Serial No. 10/020,871
Reply to Office Action of July 3, 2006

Docket No. HI-0051

Amendments to the Drawings:

FIG. 1

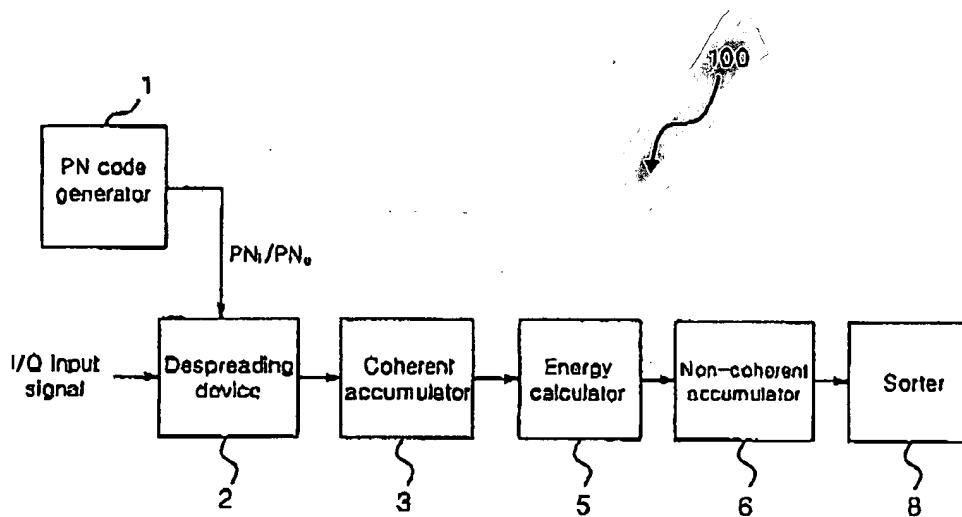
A. The Office Action objects to Figs. 1 and 3. In Fig. 1, previously omitted element 100 has been added. In Fig. 3, previously omitted element 300 has been added. Attached are Annotated Sheets and Replacement Sheets for Figs. 1 and 3. Applicant respectfully submits the above amendments obviate the grounds for the objection. Withdrawal of the objection to the drawings is respectfully requested.

The attached drawings include changes to Figs. 1-3. These sheets, which includes Fig. 1-3, replaces the original sheets including Fig. 1-3. In Fig. 1, previously omitted element 100 has been added. In Fig. 3, previously omitted element 300 has been added.
